SECTION 00 9112
ADDENDUM NUMBER 2

DATE: 03/02/2021
PROJECT: CITY OF MILLERSBURG FIRE STATION 15
ARCHITECT'S PROJECT NUMBER: 20006
OWNER: CITY OF MILLERSBURG
ARCHITECT: SODERSTROM ARCHITECTS

1 SF HEAD AT BOX RIB
3" = 1'-0"

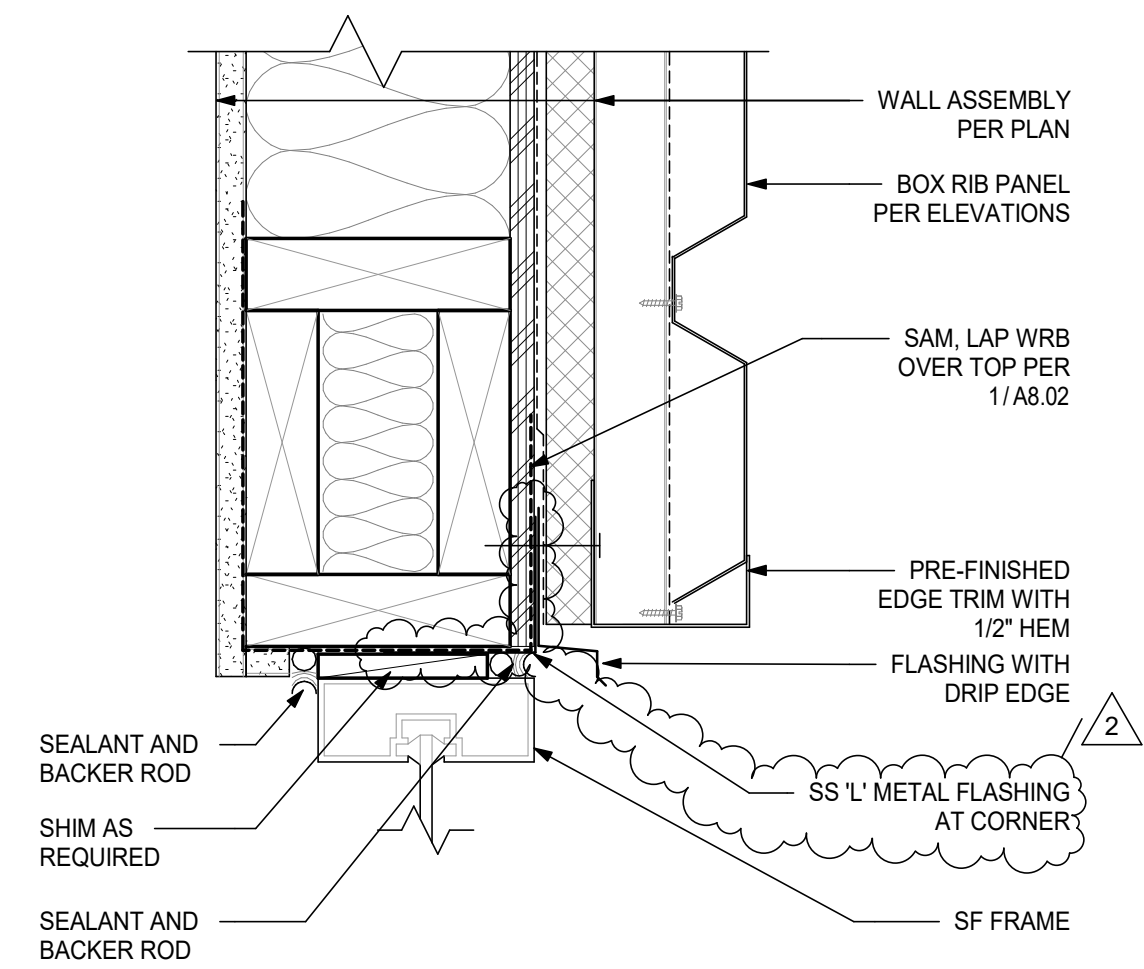
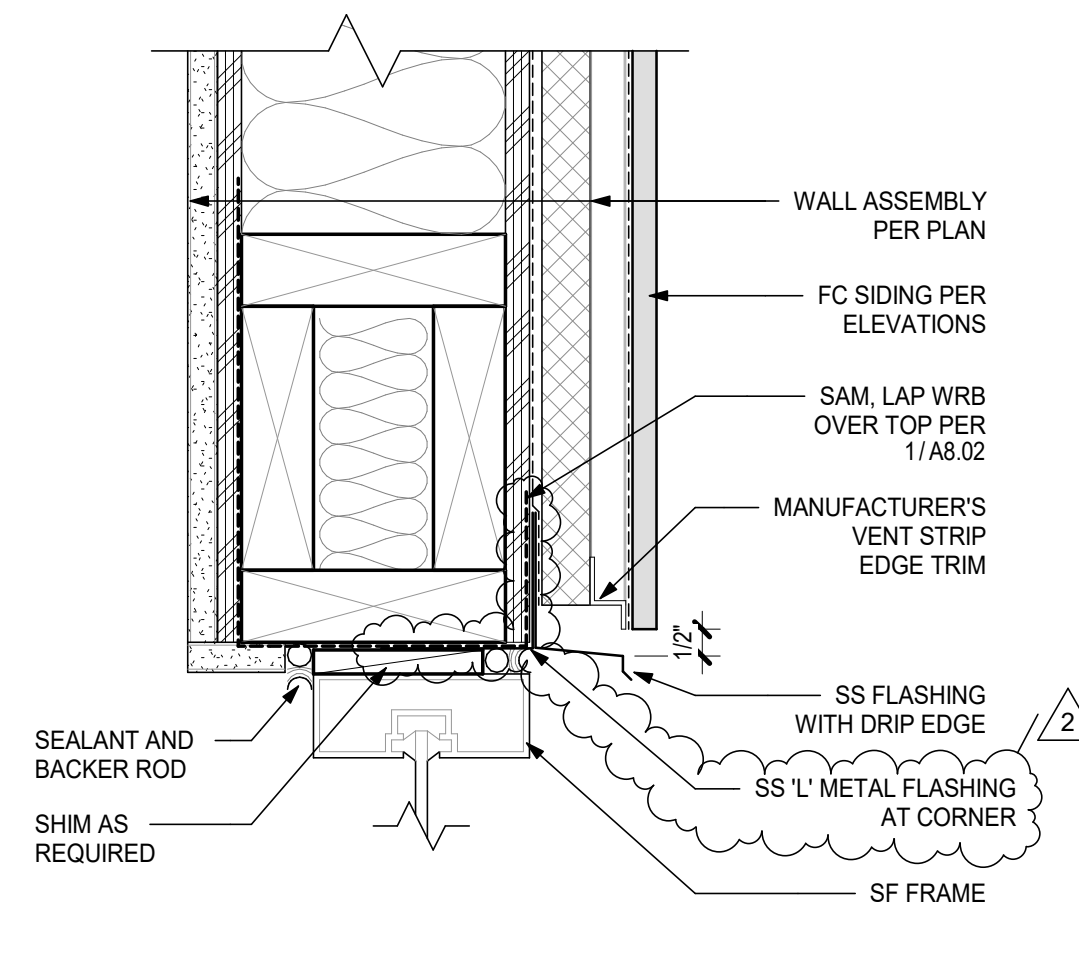
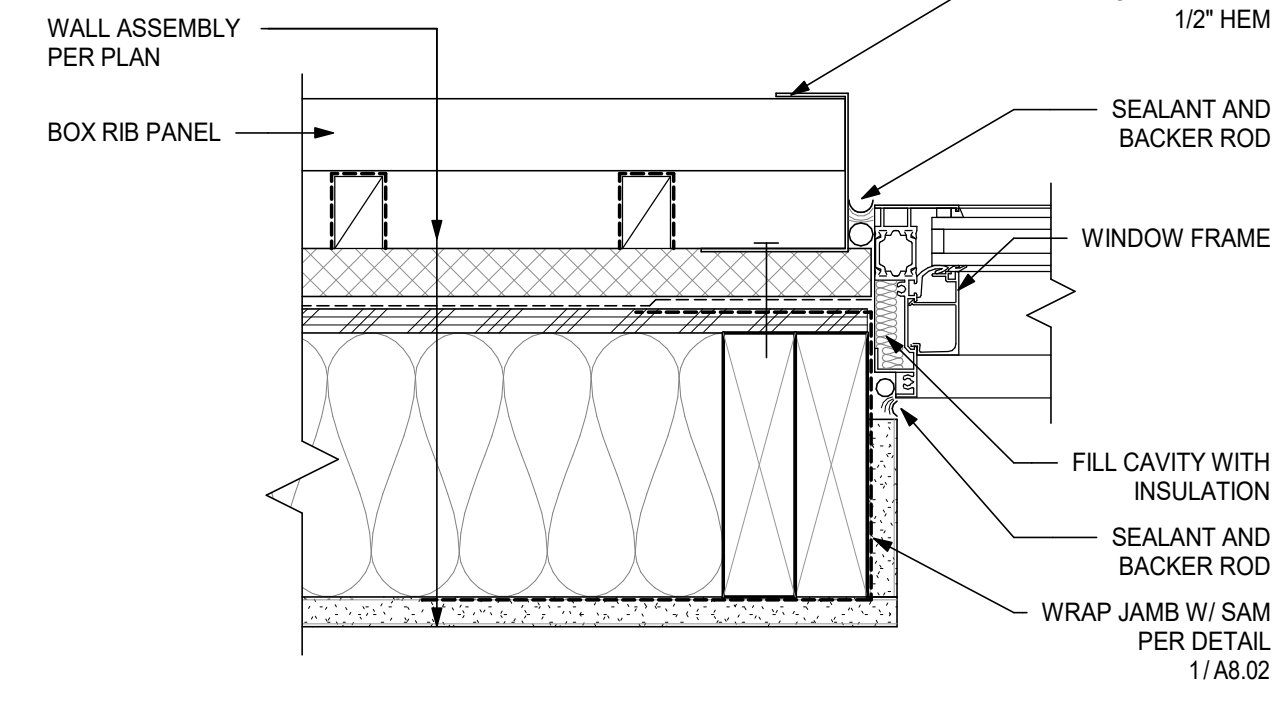
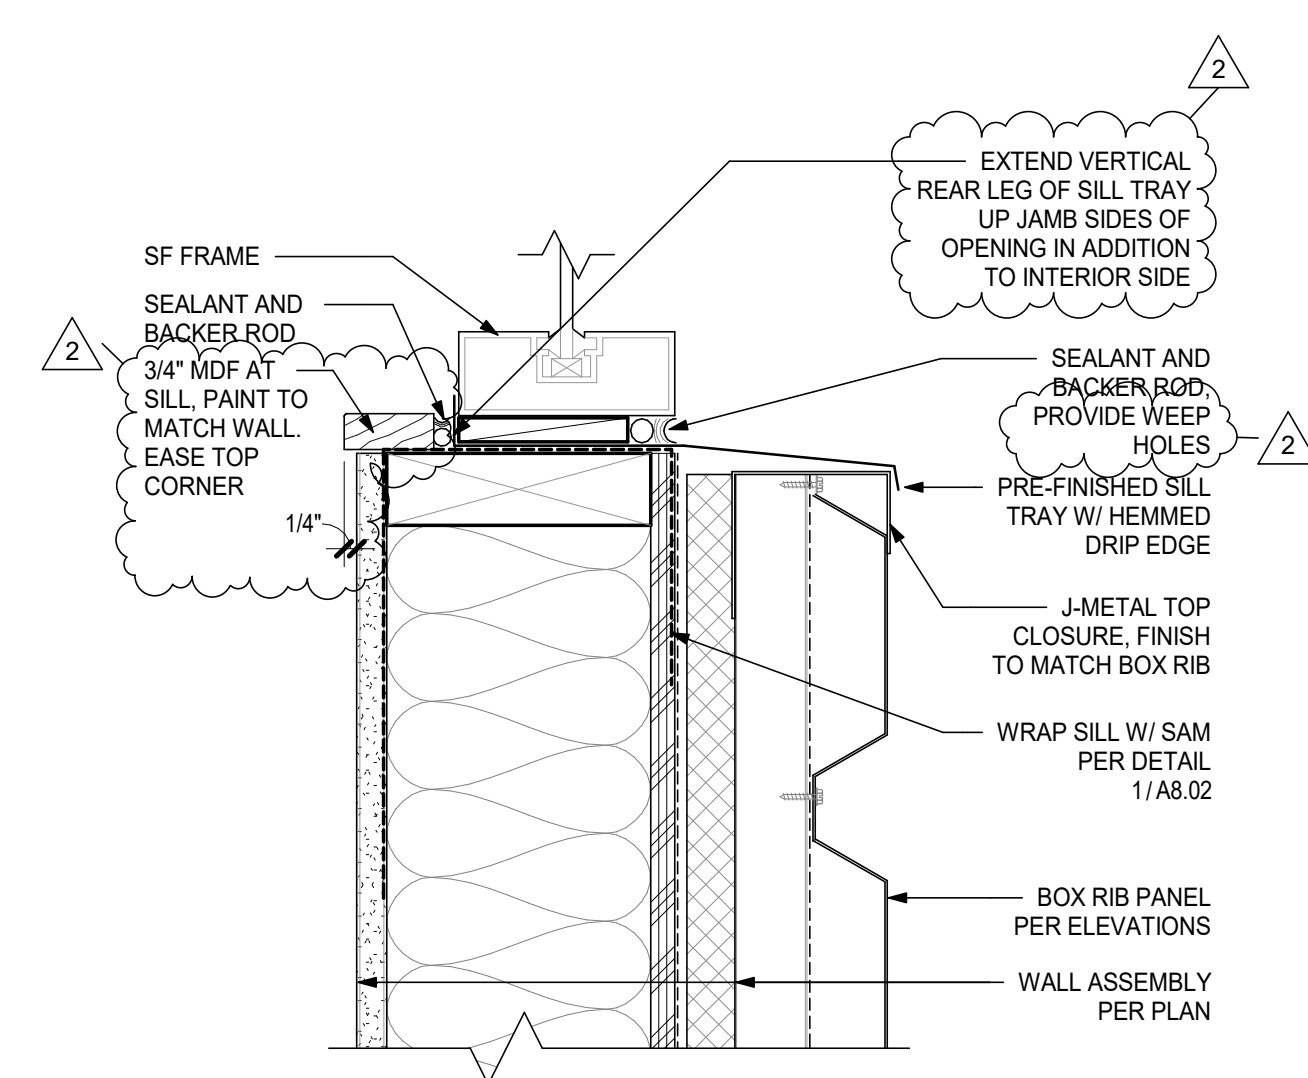
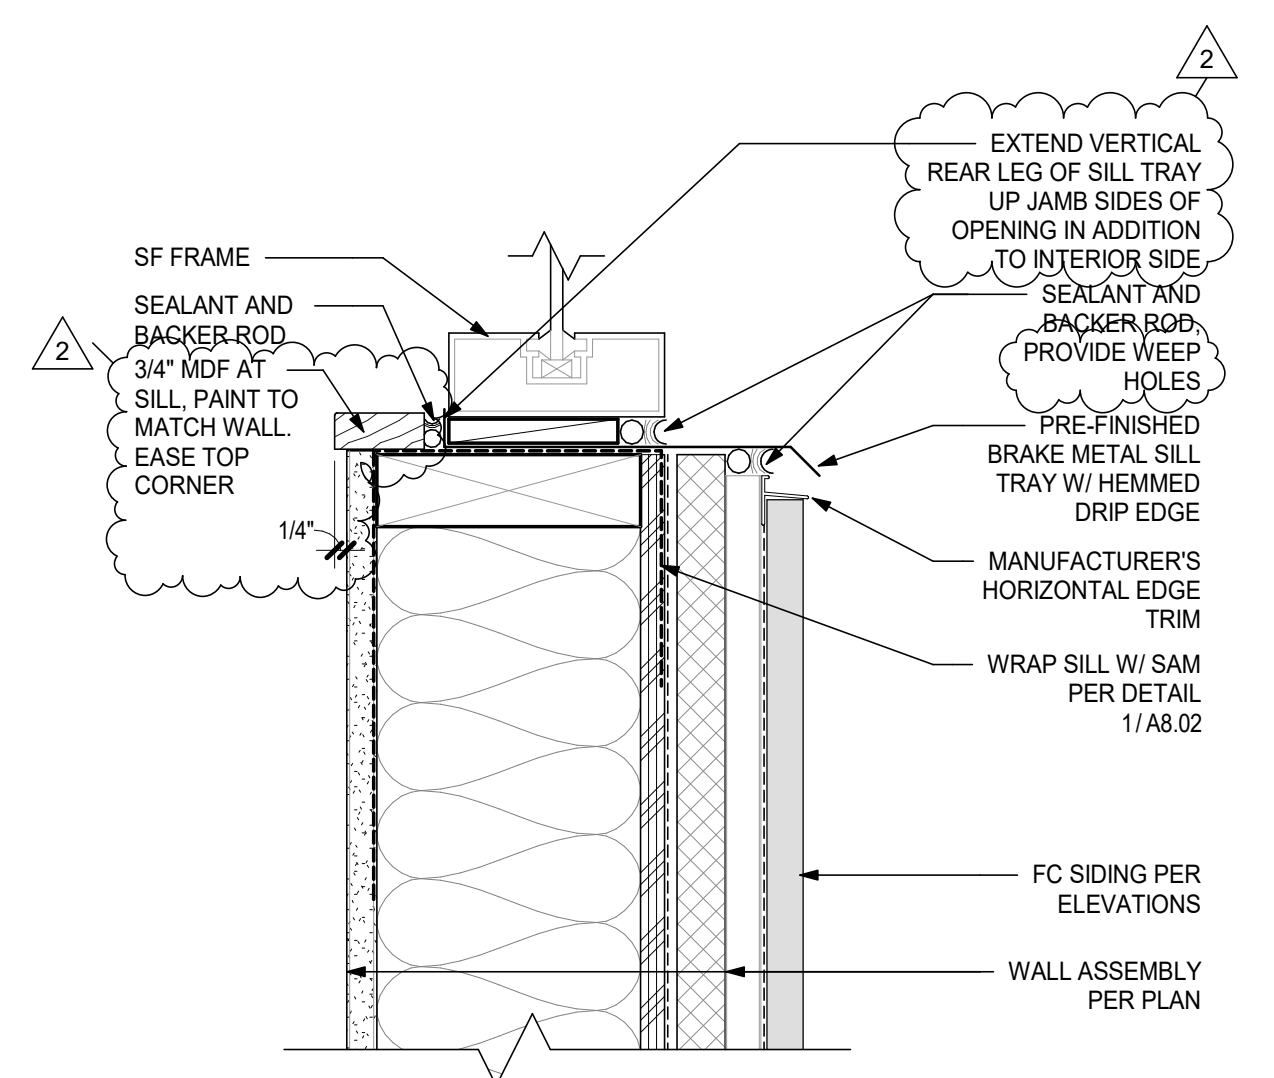
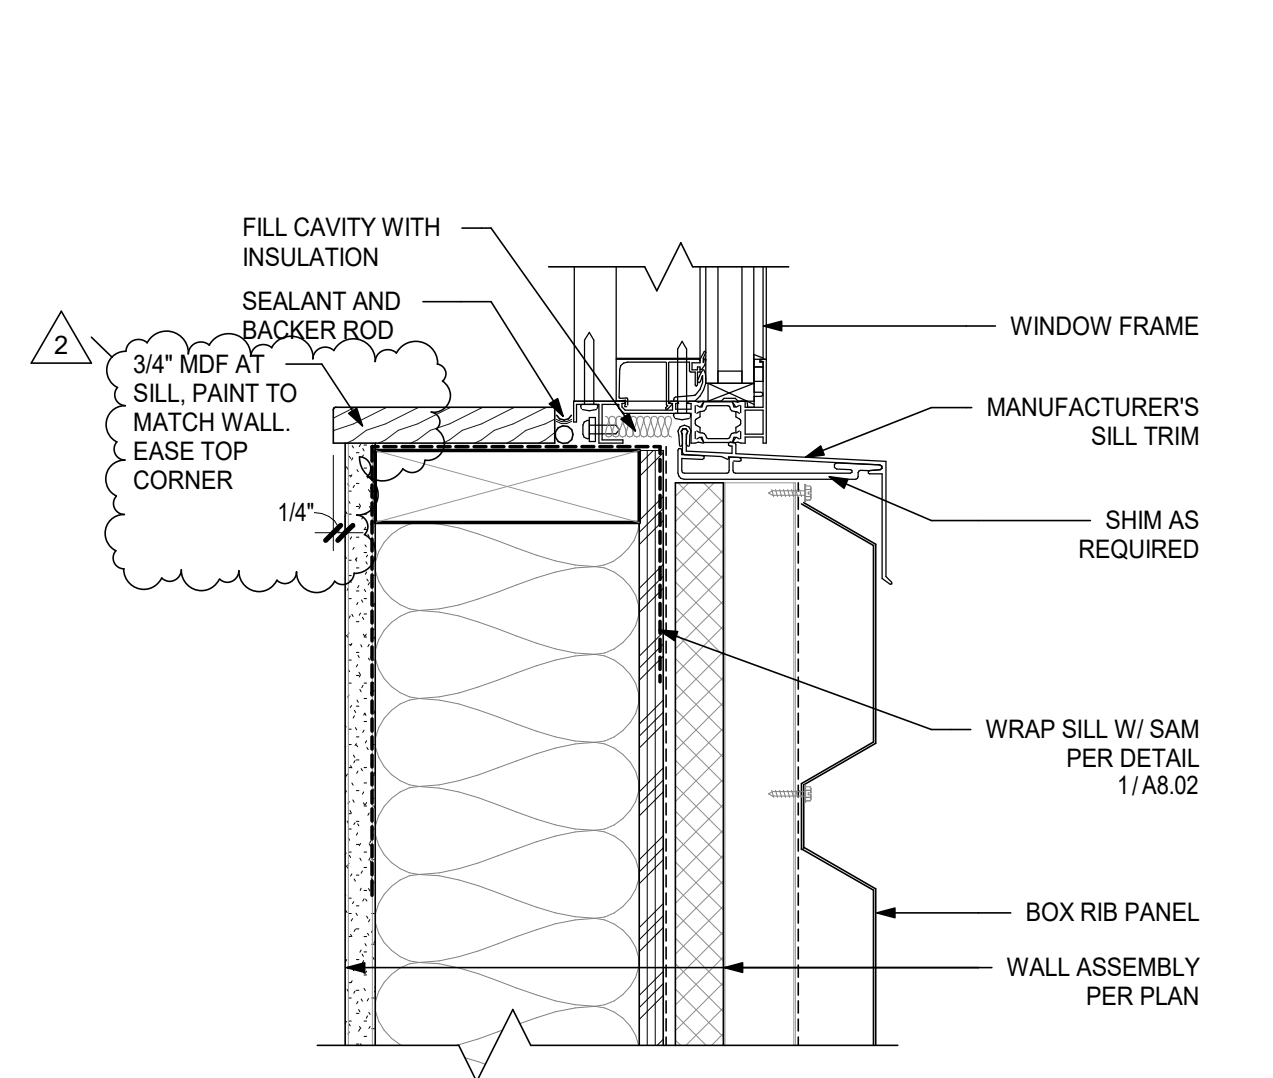
DRAWING A8.13

Revise Details 1, 2, 5, and 6 to add stainless steel L flashing

Revise Details 9, 10, and 11 to show MDF sill

Revise Details 9 and 10 to clarify sill tray and sealant

- A. A stainless steel L flashing has been added at storefront jambs at heads. See revised details 1, 2, 5, and 6 issued with this addendum.
- 67. Edge of gyp board at sealant joints (wherever there is a wrapped/cut gyp board edge) should typically have "L-metal" trim for neat caulk-joint appearance. Please add note.**

- A. A sill tray is provided at the base of all storefront assemblies for drainage. Details 9 and 10/A8.13 have been updated to clarify that the vertical legs of this should be extended up jambs as well, as well as providing weep holes.
